200331636 Wireless IoT Modules Tracecode and 2D Barcode Change for Zentri

Bulletin Issue Date: 3/31/2020

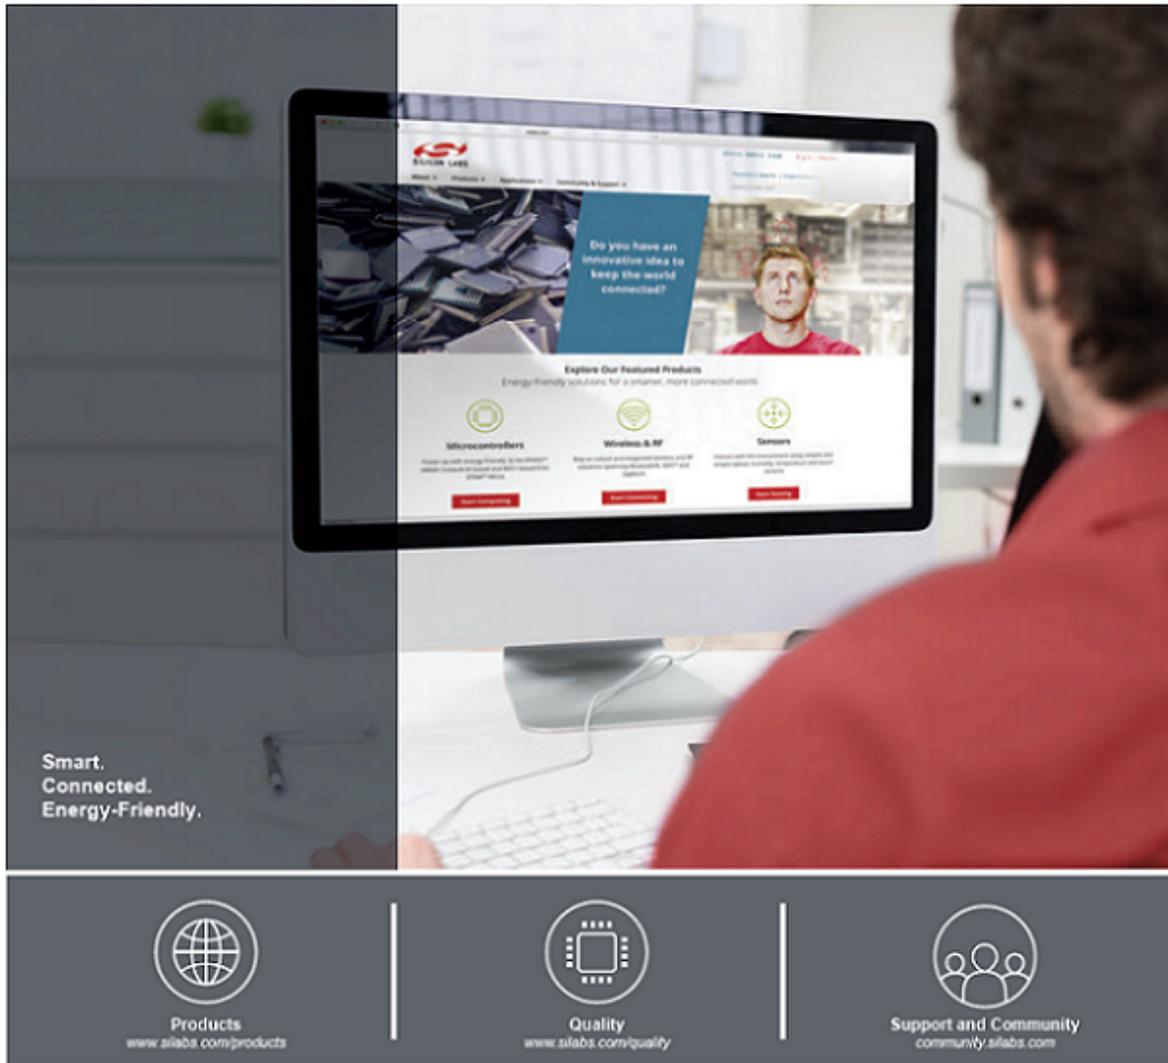
Silicon Labs is pleased to announce the standardization and implementation of the tracecode for batch level traceability and 2D barcode for unit level traceability for Zentri modules. The marking label is replaced with shield marking. The detailed tracecode description can be found at document "Wireless IoT Modules Master Errata for Zentri Shield Marking" available for download in www.silabs.com.
